IN no.: **IN-149 rev 1.0.1**

Date: **2021-09-08**

nRF52833-QIAA, nRF52833-QDAA and nRF52833-CJAA

The nRF52833 revision 2 (build code Bx0) introduces four changes to the product.

Changes to pin-out:

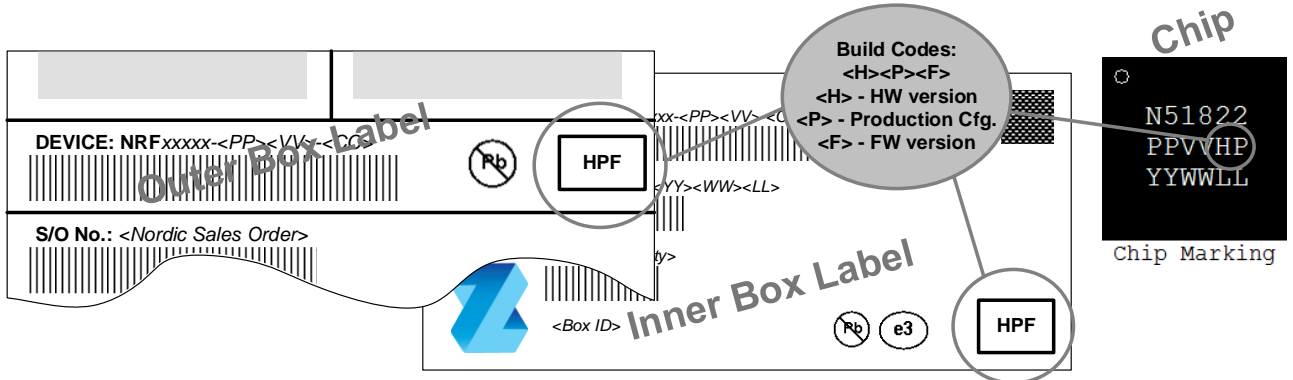
Existing PCB designs for the nRF52833 (rev. 1) are compatible with the nRF52833 rev. 2 without performance degradation. For new designs an updated bill of material for the reference schematic is available in the product specification rev. 1.4 or later. The new bill of material requires one less decoupling capacitor.
